Phase II Field Sampling Plan

University of California, Berkeley
Richmond Field Station, Richmond, California

September 12, 2011

Response to Comments
Department of Toxic Substances Control, August 11, 2011

**FIGURE 2
SITE MAP**

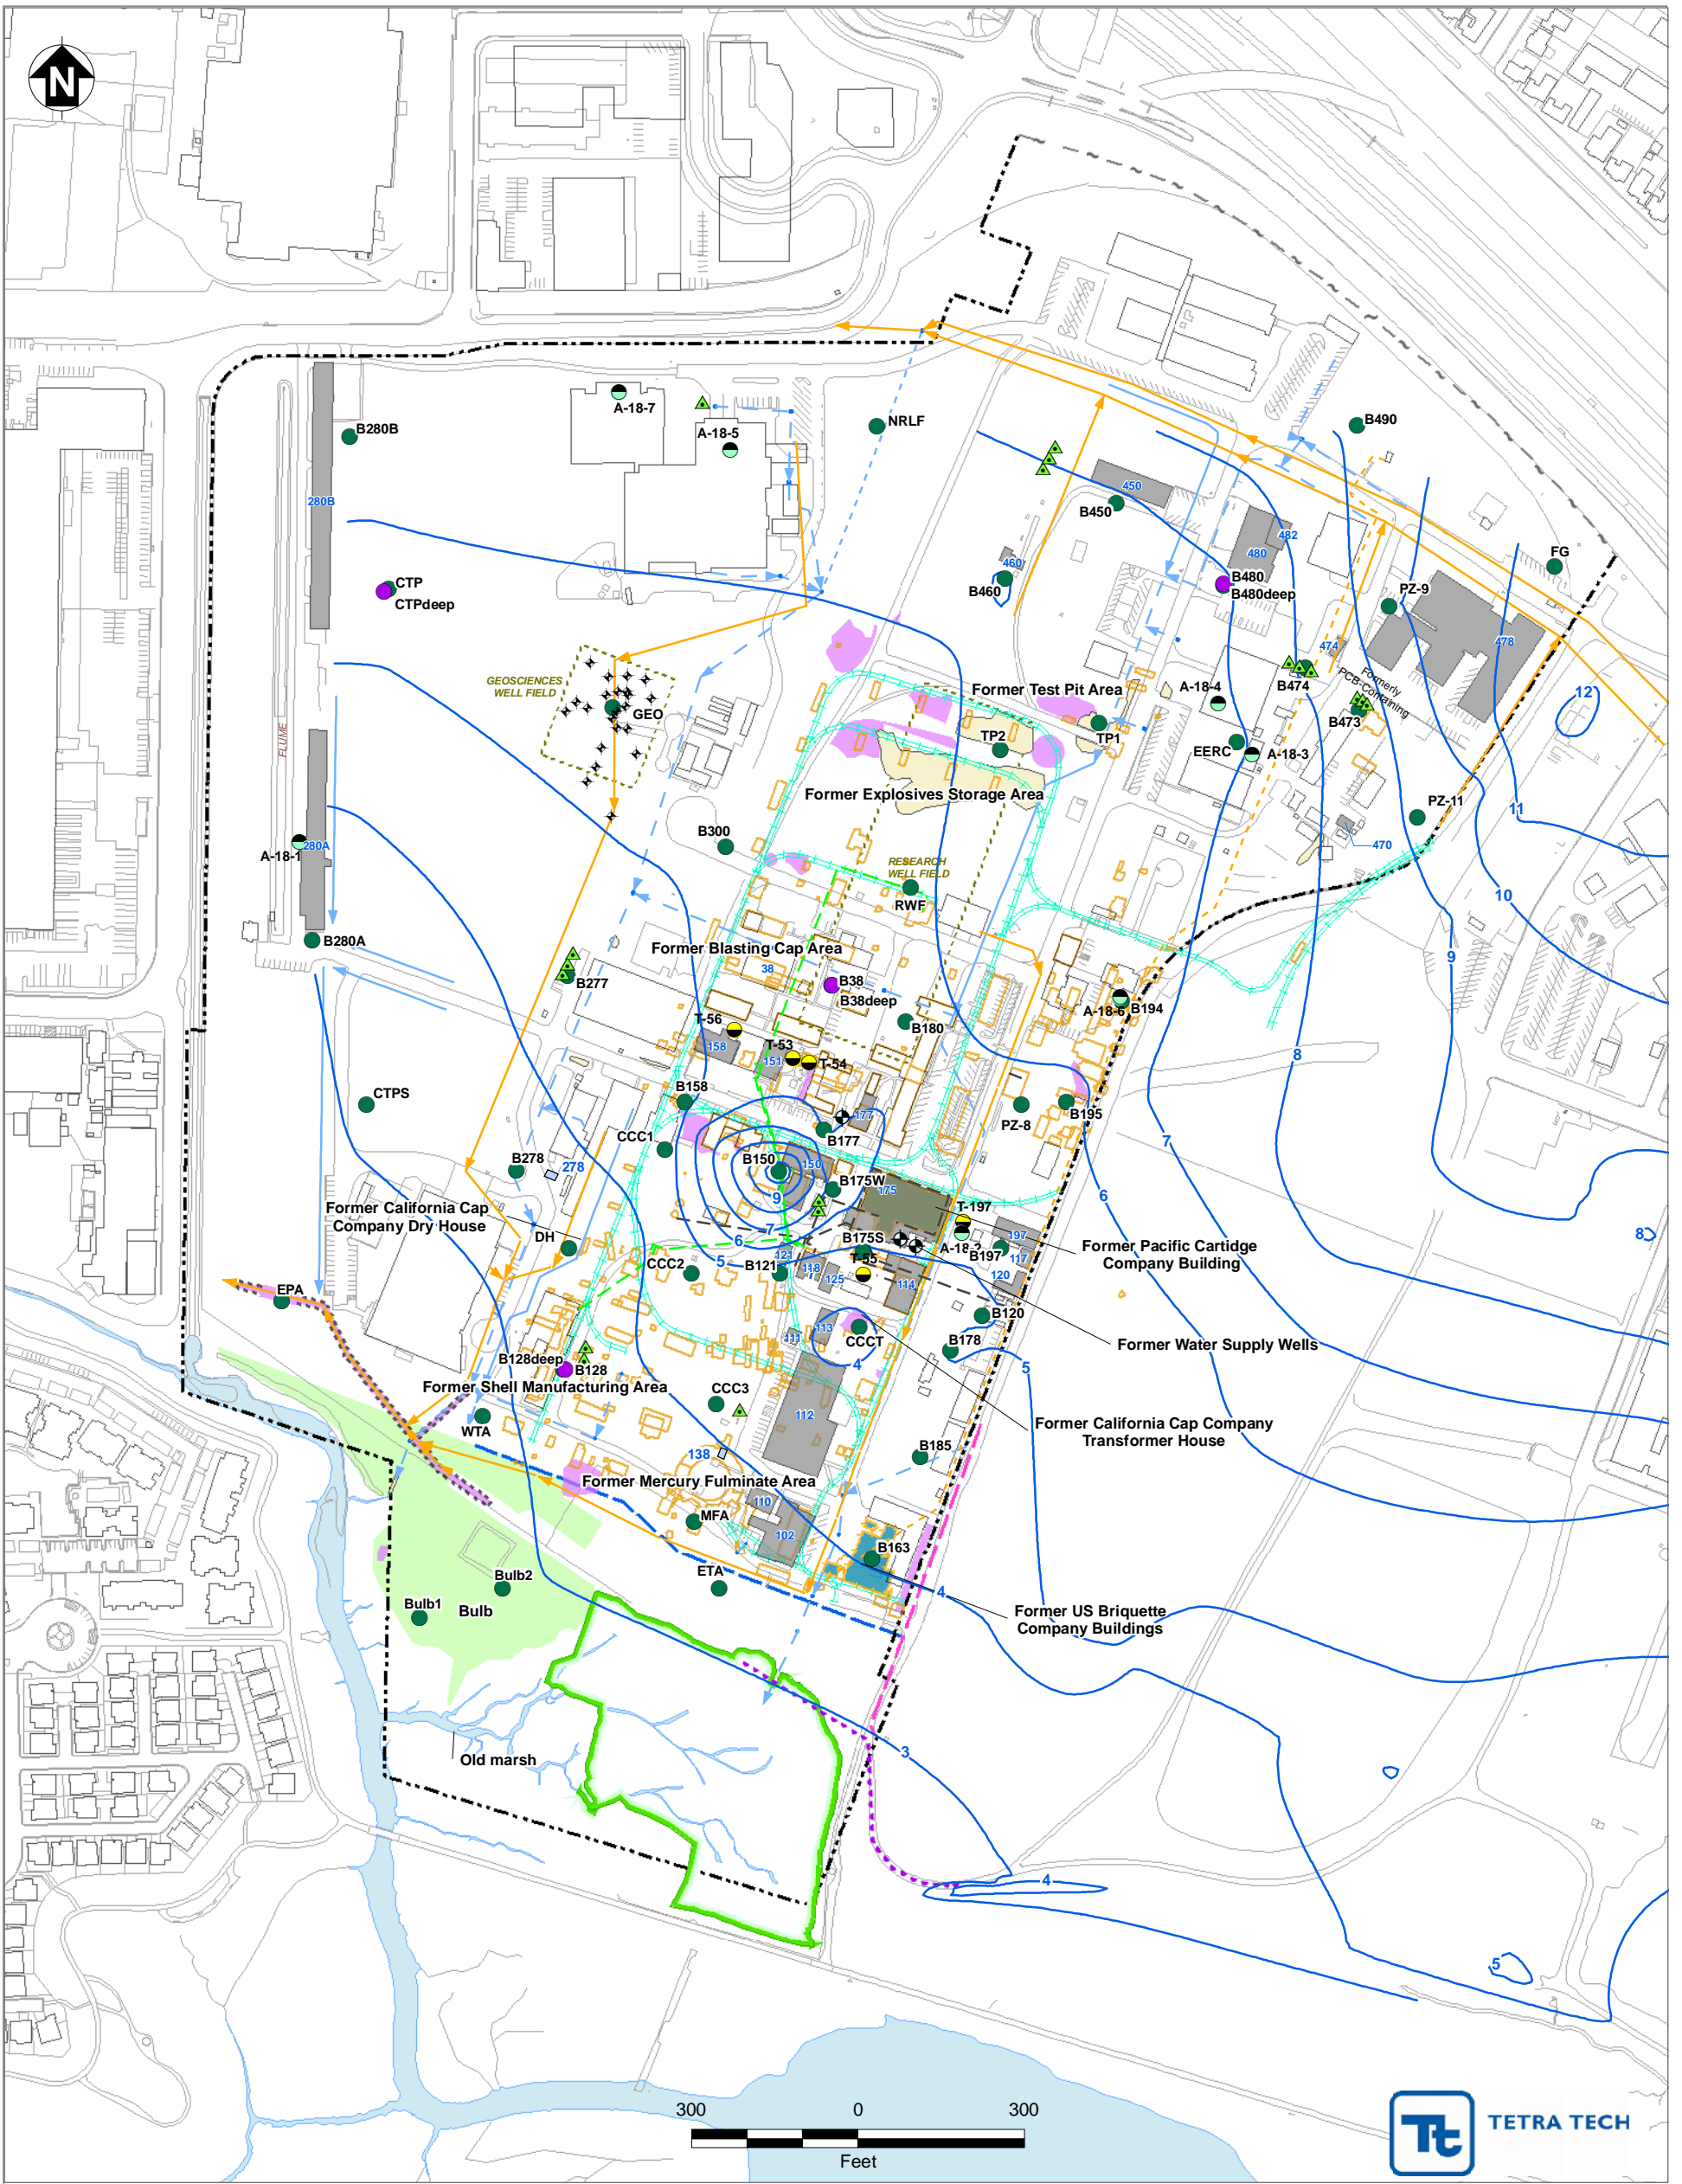
1. Page 1, section 1.1, Physical Setting, third paragraph of section. For clarification, is the 96 acres of upland habitat exclusive of land developed with roads, parking lots and buildings? Figure 2 shows the stream race in the western portion of the area designated as Upland Area, There are also structures associated with the "NLRF" and other unidentified structures in the northern portion and, of course, there is the main building complex and associated parking lots and roads in the eastern portion. The report states that all proposed samples of the '*The proposed Phase II sampling locations are all located in the Upland area*'.

UC Berkeley Ref. No.	Page/ Sect No.	DTSC Comment	UC Berkeley Response
9		<p>Page 1, section 1.1, Physical Setting, third paragraph of section. For clarification, is the 96 acres of upland habitat exclusive of land developed with roads, parking lots and buildings? Figure 2 shows the stream race in the western portion of the area designated as Upland Area. There are also structures associated with the "NLRF" and other unidentified structures in the northern portion and, of course, there is the main building complex and associated parking lots and roads in the eastern portion. The report states that all proposed samples of the 'The proposed Phase I sampling locations are all located in the Upland Area'.</p>	<p>Yes, the 96 acres designated as the Upland Area includes all of the land shaded in yellow on Figure 2, including land developed with roads, parking lots, and buildings.</p>
10	Page 11, Section 3.2	<p>Pages 10 and 11, Data Quality Objectives, Step 4: Define the Boundaries of the Study. For the historic transformer locations, the soil from 0-2 feet below ground surface (bgs) will be investigated since PCBs are readily sorbed to soil and are most likely to stay in the shallow horizon from a surface spill. ERAS generally agrees with this statement, except if the surface soil position has changed since the time of the spill, for example if the site was graded at some point after the spill. A case in point is the transformer location east of Building 128 where the tower mounted transformers were struck by lightning. The parking lot immediately adjacent to the transformer tower was apparently not yet constructed at the time of the lightning strike. It is possible that ejection of PCB-containing dielectric fluid coupled with wind could have spread PCBs to soil under the now graded parking lot. The location of potentially released PCBs at this transformer location could have changed not only in lateral extent but also in soil depth from the location and depth of their original deposition.</p> <p>Step 6: Specify Performance or Acceptance Criteria. Many of the sample locations are located in areas that are not habitat and will not be habitat in the future</p> <p>However, some sample locations like B27701-B27704 and sample locations EERC01 and EERC02 could be within habitat areas. Therefore, in addition to the listed human health soil screening Levels (CHHSLs, RSLs and TSCA values) Step 6 should also include ecological soil screening levels.</p>	<p>In most transformer locations, the historic grade and current grade appear to be the same. The potential for soil disturbance and subsequent PCB redistribution was discussed with DTSC during the May 12, 2011 site walk when sampling locations were selected. In the case of the Building 128 transformer, the soil directly under, and directly adjacent to the transformer platform do not appear to have been disturbed. Sampling locations were placed near the platform, as well as close to the more recently constructed asphalt pad. These locations provide adequate coverage for the area. Additionally, the DQOs state that if elevated concentrations of PCBs are detected, expansion of the study boundaries may be necessary.</p> <p>Some of the proposed sampling locations are located in areas which will require abbreviated or full ecological risk assessments, as identified in the 'Ecological Strategy for Upland Habitat' submitted to DTSC on June 26, 2009. Therefore the ORNL plant screening benchmark was added to the list of soil screening levels.</p>

FIGURE 5
FORMER PCB TRANSFORMER
AND AST
PROPOSED SAMPLING LOCATIONS
Field Sampling Plan

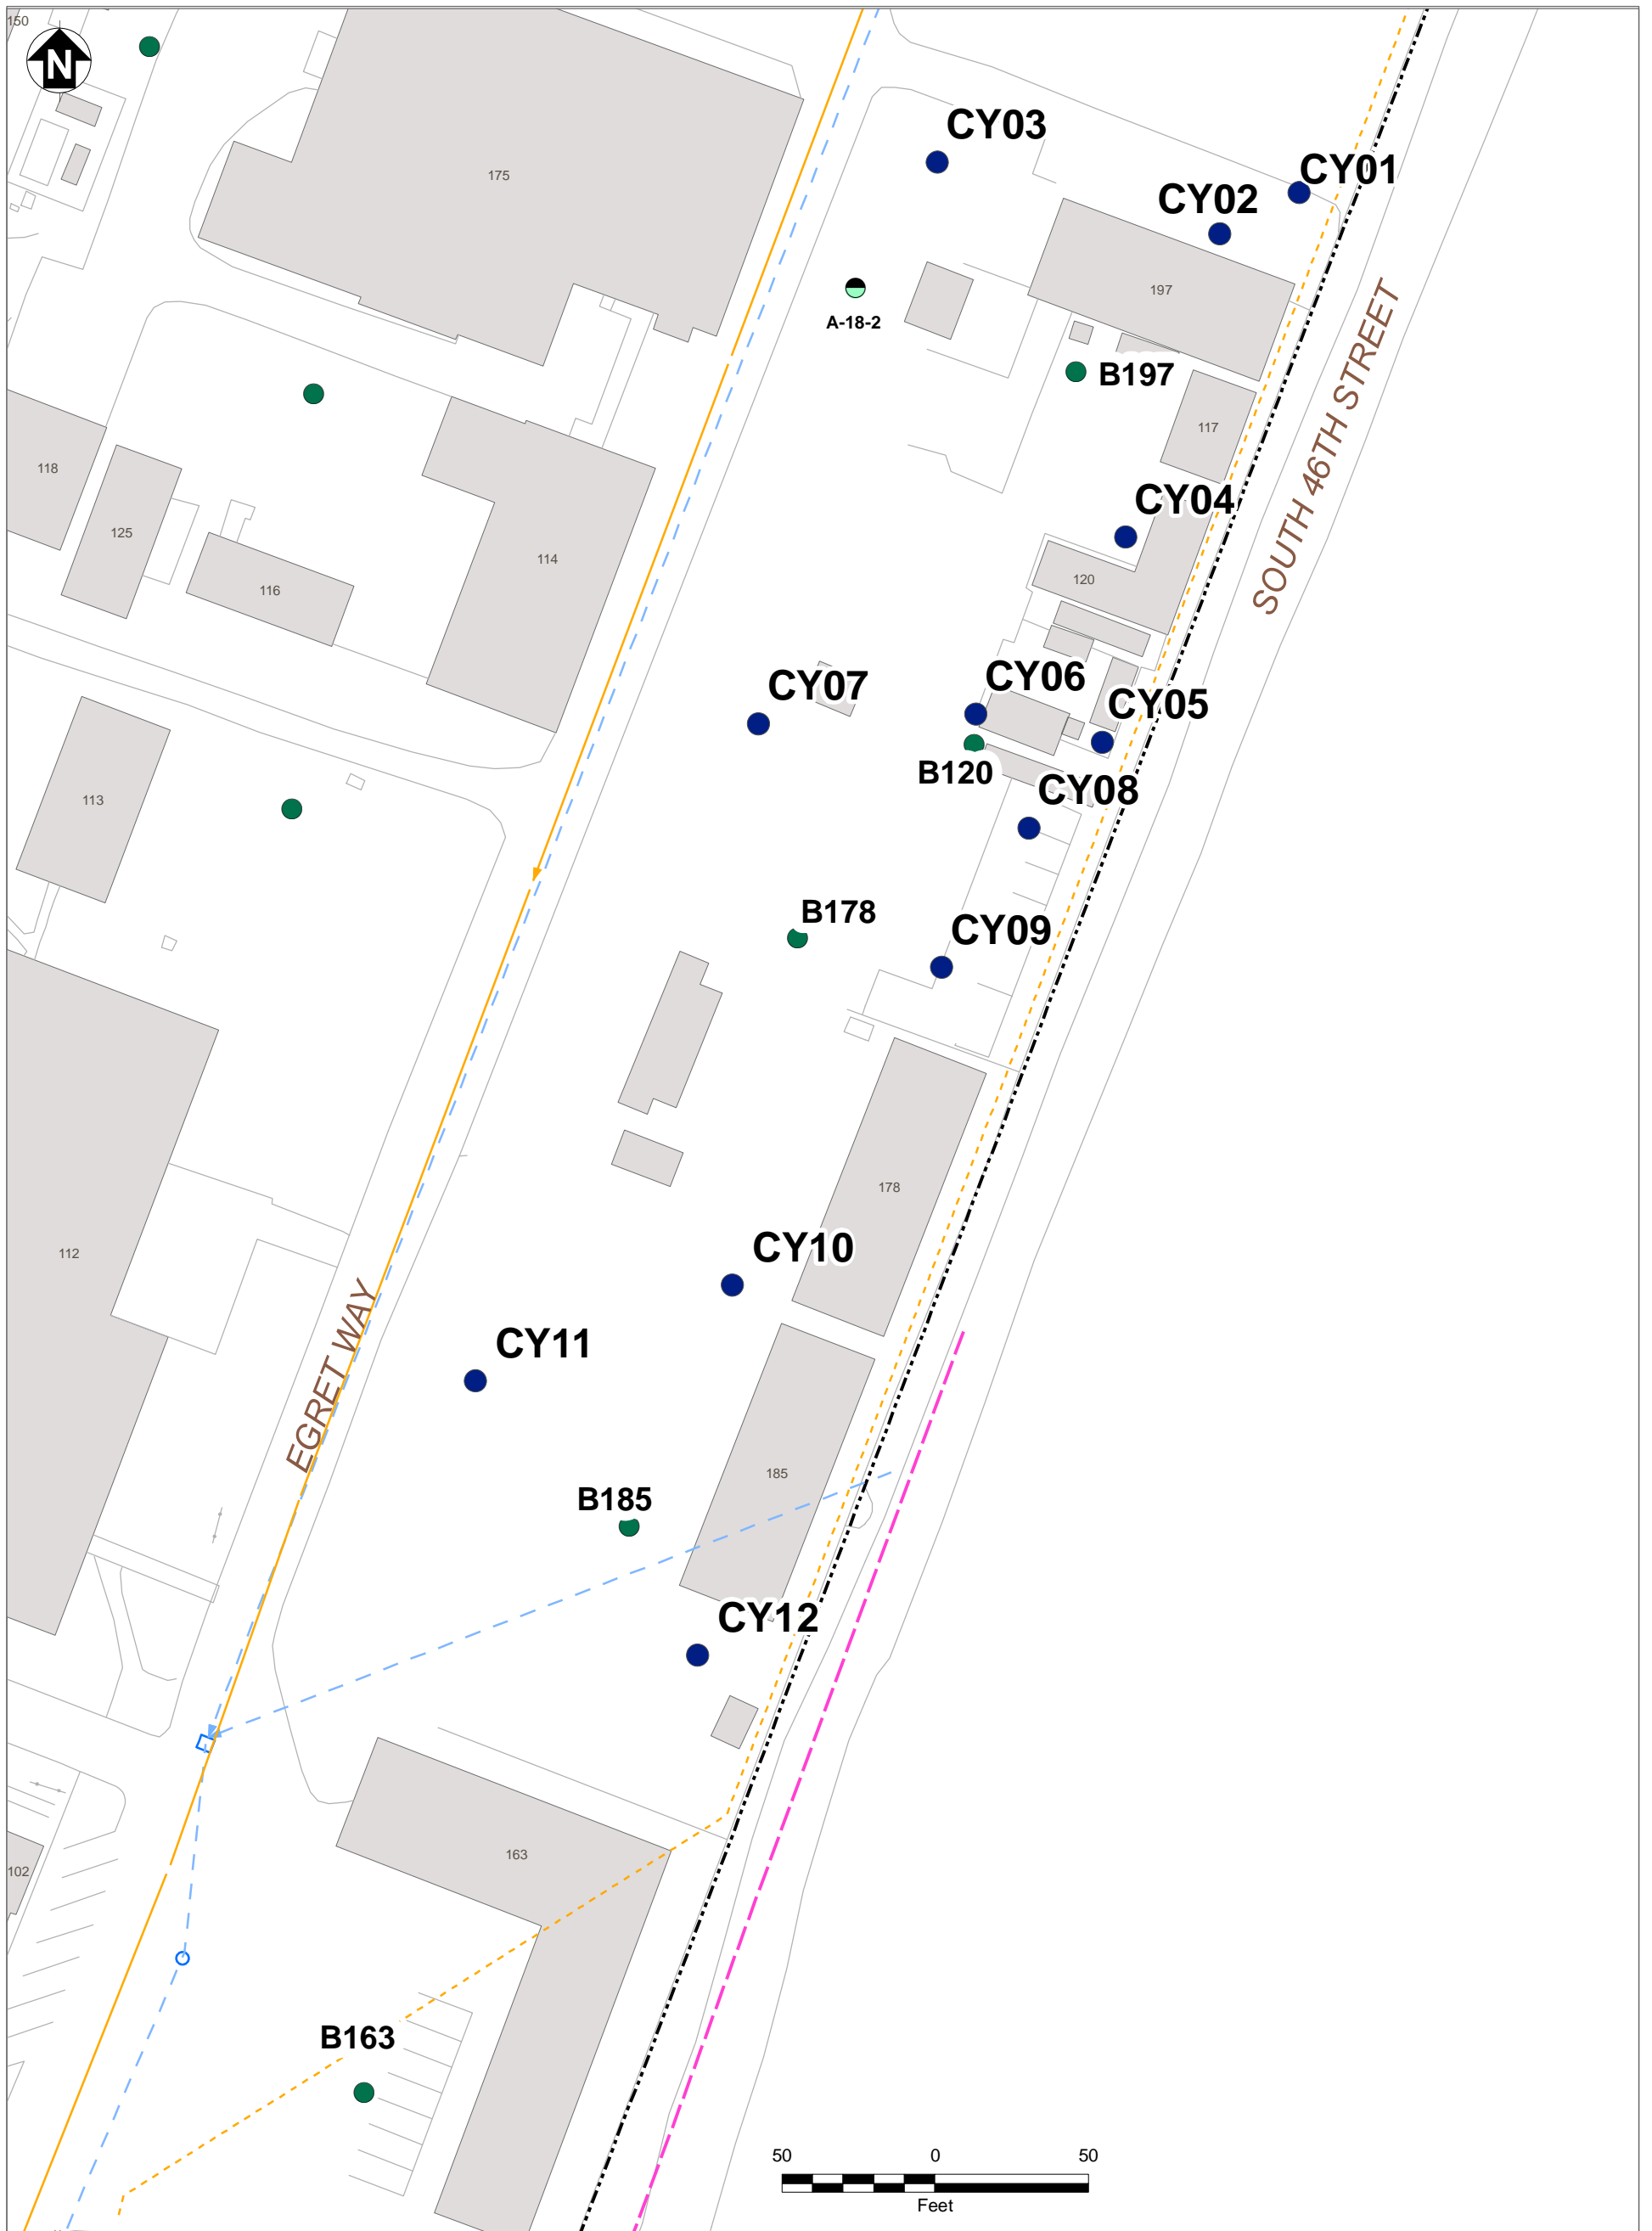
8. Figure 5: To provide greater clarity, the blow-up boxes in Figure 5 should be further identified to provide pictorially the rationale for sampling in each of the areas. In addition, the correlation between the sample locations identified in the figure and the text in Section 3.3 (Sampling Process Design) needs to be explained more fully. For example, the blow-up boxes in Figure 5 could be numbered and the numbers referred to in Section 3.3.

8	Page 11, Section 3.3.1 and Figure 5	<p>Figure 5: To provide greater clarity, the blow-up boxes in Figure 5 should be further identified to provide pictorially the rationale for sampling in each of the areas. In addition, the correlation between the sample locations identified in the figure and the text in Section 3.3 (Sampling Process Design) needs to be explained more fully. For example, the blow-up boxes in Figure 5 could be numbered and the numbers referred to in Section 3.3.</p>	<p>Figure 5 has been amended to include numbered insets and the text in Section 3.3 has been updated to contain references to the figure.</p>
